UNITED STATES PATENT AND TRADEMARK OFFICE

APPLICATION NO.	FILING DATE	FIRST NAMED INVENTOR	ATTORNEY DOCKET NO.	CONFIRMATION NO.
10/809,042	03/25/2004	Andrew Michael Duggan	CRUJ/0012	5804
7590 05/01/2009				
WILLIAM B. PATTERSON		EXAMINER		
MOSER, PATTERSON & SHERIDAN, L.L.P.		SULLIVAN, DEBRA M		
Suite 1500		ART UNIT	PAPER NUMBER	
3040 Post Oak Blvd.		3725		
Houston, TX 77056				
		MAIL DATE	DELIVERY MODE	
		05/01/2009	PAPER

Office Action Summary	Application No. 10/809,042	Applicant(s) DUGGAN ET AL.
	Examiner Debra M. Sullivan	Art Unit 3725

DETAILED ACTION

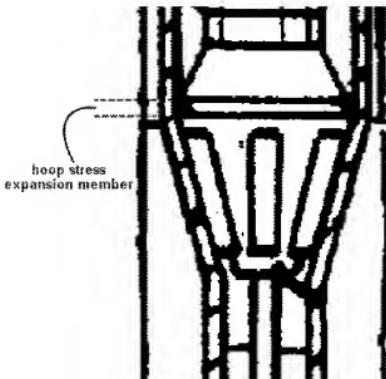
Claims 1-3, 6-19, 22, 23, 25, 29-35, 42, 43, 49, 52, 53, 63-65 and 98-100 are rejected under 35 U.S.C. 102(e) as being anticipated by Metcalfe et al (US Patent # 6,543,552 B1). Metcalfe et al discloses an apparatus for lining a wellbore having an expansion device (20) having expansion members (38) adapted to expand a tubing by inducing a compressive yield and expansion member (See FIG below), comprising of an expansion cone, adapted to expand a tubing by inducing a hoop stress in the tubing such that the compressive yield expansion members (38) expands a tubing (18) to a first diameter and the hoop stress expansion members (See FIG below) expands the tubing to a second larger diameter. Metcalfe et al further discloses the hoop stress and compressive yield (38) are arranged according to the desired post expansion

diameter in the tubing (18) [See col. 3 lines 6-10] and are spaced alternately in an axial direction and a circumferential direction. The hoop stress inducing expansion member and the compressive yield inducing expansion members (38) are provided on separate portions coupled together wherein a hoop stress inducing tool carries the hoop stress expansion member and the compressive yield inducing tool (30) carries the compressive yield expansion members (38). The hoop stress inducing expansion member is fixed relative to a remainder of the device (20) and are integrally formed with a body of the expansion device (20). The hoop stress members are rotatable with respect to the tubing and rotatably mounted on a body of the device (20). The compressive yield inducing expansion members (38) comprise of a rotary expansion member that rotates about an expansion axis. The compressive yield expansion members (38) are radially movable mounted with respect to the body of the device (20) for movement towards an expansion configuration by applied fluid pressure. The compressive yield inducing expansion members (38) is adapted to expand the tubing (18) by less than 50% or 25% or 10% of the total expansion of the tubing. It is noted that claims 2-4 and 14-19 do not further limit the structure of the expansion device but the disclosure of Metcalfe et al meets the required criteria of the claimed subject matter. [See FIGS 1-3 and col. 5 line 51 – col. 6 line 4].
